SUNDRY NOTICES AND REPORTS ON WELLS (DO NOT USE THIS FORM FOR PROPOSALS TO DRILL OR TO DEEPEN OR PLUG BACK TO A DIFFERENT RESERVOIR. USE "APPLICATION FOR PERMIT" (FORM C-101) FOR SUCH PROPOSALS.)		WELL API NO. 30-005-62686
1. Type of Well: Oil Well ☒ Gas Well ☐ Other ☐		5. Indicate Type of Lease STATE ☒ FEE ☐
2. Name of Operator The Eastland Oil Company		6. State Oil & Gas Lease No. L06773-0000
3. Address of Operator PO Box 3488 Midland, TX 79702		7. Lease Name or Unit Agreement Name Eastland State
4. Well Location Unit Letter <u>D</u> : <u>660</u> feet from the <u>North</u> line and <u>660</u> feet from the <u>West</u> line Section <u>13</u> Township <u>09S</u> Range <u>26E</u> NMPM Chaves County		8. Well Number <u>4</u>
11. Elevation (Show whether DR, RKB, RT, GR, etc.)		9. OGRID Number 22767
		10. Pool name or Wildcat Foor Ranch; Pre Permian

Eastland State #4

30-005-62686

Operator: EASTLAND OIL CO P.O. Box 3488 Midland, TX 79702	OGRID: 22767
	Action Number: 379532
	Action Type: [C-103] NOI Plug & Abandon (C-103F)

Current Wellbore Diagram

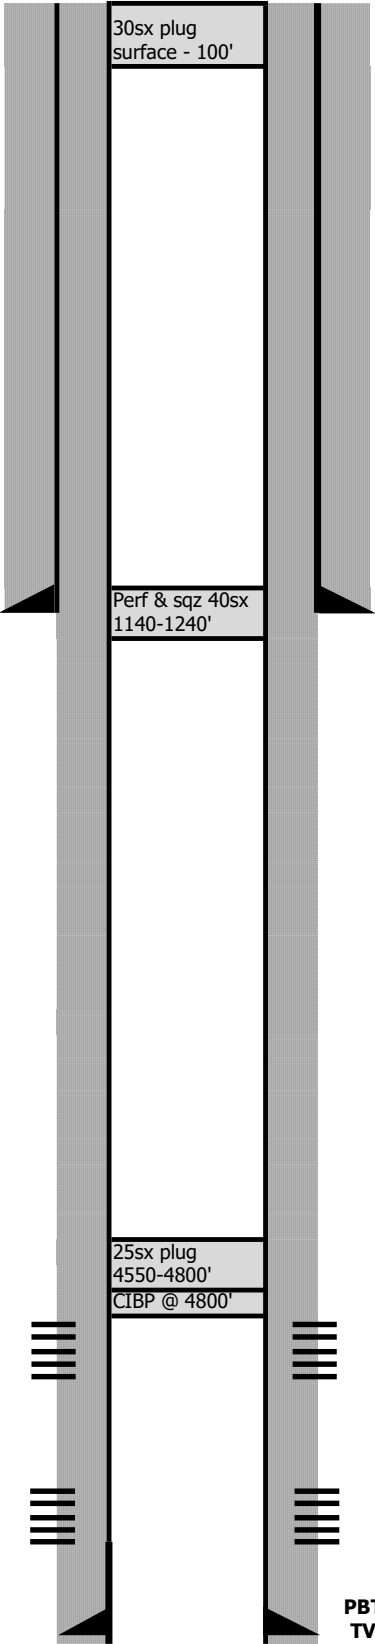
Created By	Condition	Condition Date
loren.diede	Notify NMOCD 24 hours prior to beginning P&A operations.	9/25/2024
loren.diede	Run CBL from 4800' to surface.	9/30/2024
loren.diede	Submit CBL into NMOCD Imaging via Electronic Permitting.	9/30/2024
loren.diede	Set the first CIBP at 5230'. Spot a plug of 25 sx above CIBP to cover the Wolfcamp formation top. WOC, tag plug.	9/30/2024
loren.diede	Set second CIBP at 4800'. Spot a cement plug of 25 sx to cover the Abo formation top.	9/30/2024
loren.diede	Perforate at 1407' and place a plug from 1407' to 1257' to cover the San Andres formation top.	9/30/2024
